1.1 PLANNING AMENDMENTS

PRINTWORKS

SECTION 2.0 REVISED COMMERCIAL SPACE PROPOSAL

FIGURE 33. Proposed Scheme - General Arrangement Plan L03

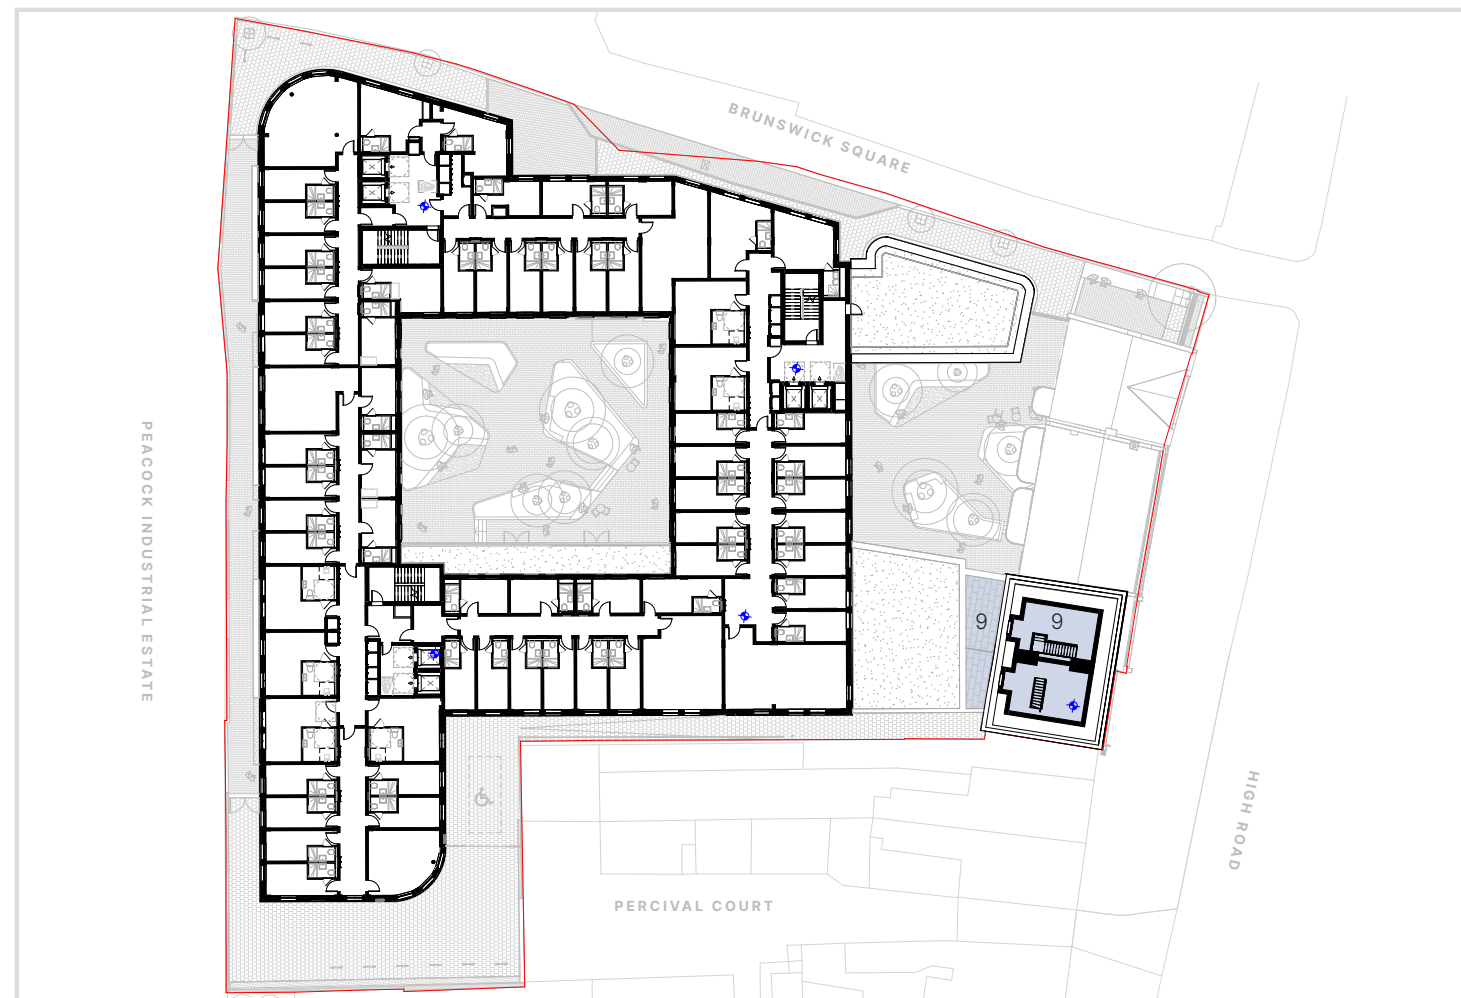
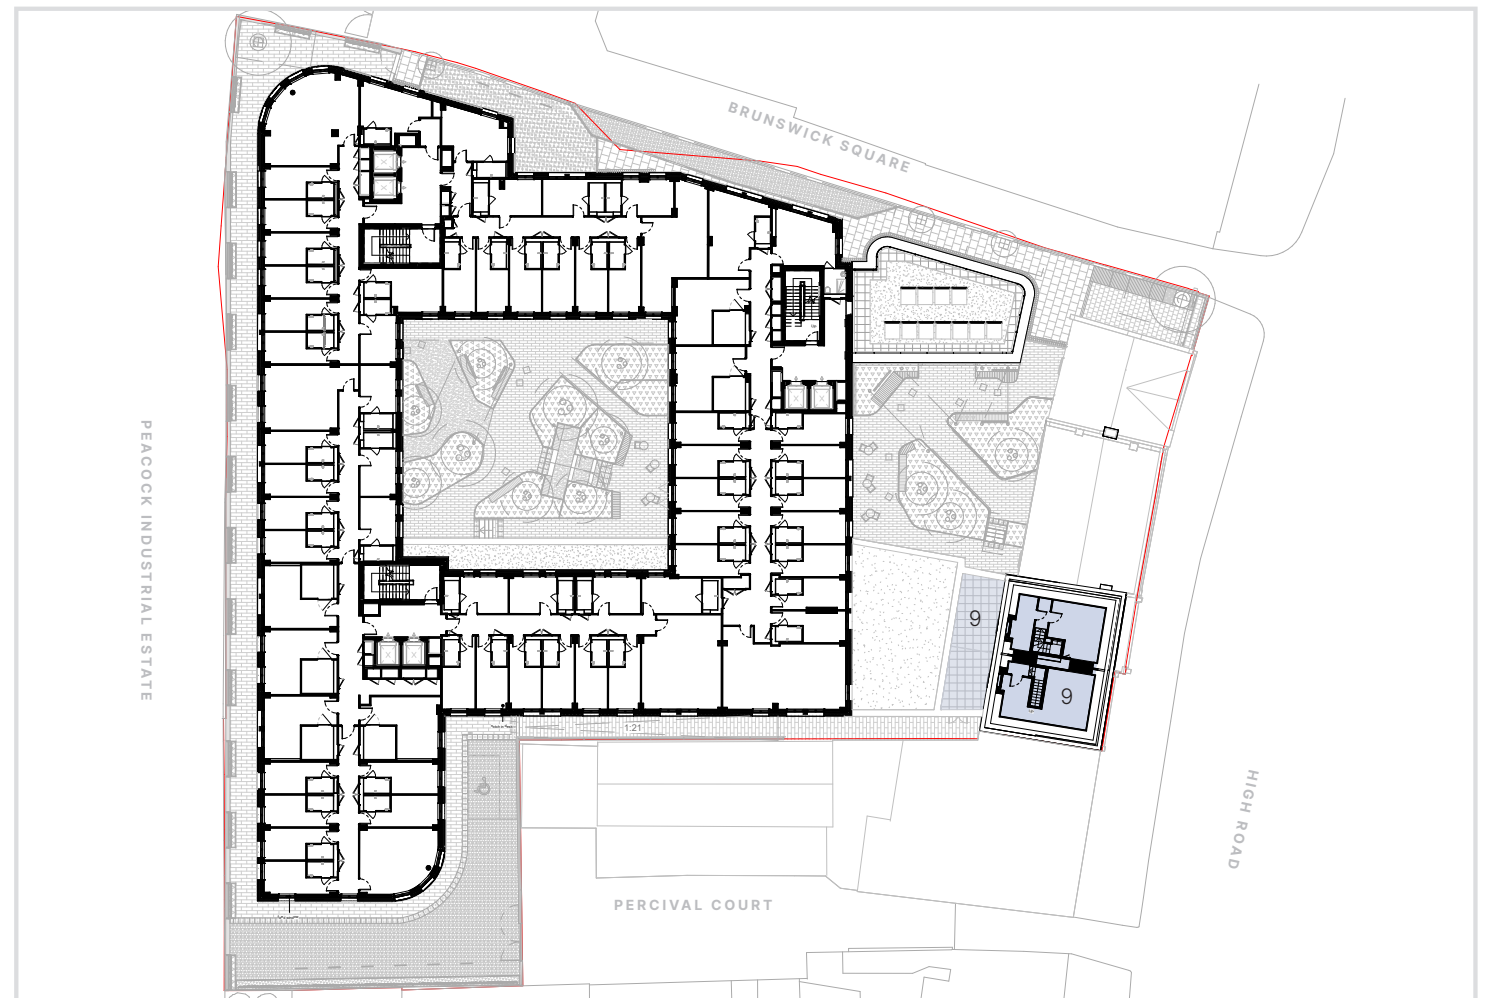
- 1 Stairs and lifts core locations adjusted to co-ordinate with riser locations and Fire strategy.
- 2 West courtyard: landscape design updated to co-ordinate with accessibility and MEWP access. East facade of the west wing moved 200mm to the east to co-ordinate with MEP
- 3 East courtyard: landscape design updated.
- 4 East courtyard gate moved inward to co-ordinate with waste management strategy.
- 5 Minor adjustment to ground finishes.
- 6 Drafting update only - High Road kerb updated with latest site survey and fire tender access strategy.
- 7 North Columns sizes adjusted and rotated to co-ordinate with updated structural plan.
- 8 1 cycle storage relocated.
- 9 Minor adjustment to layout.
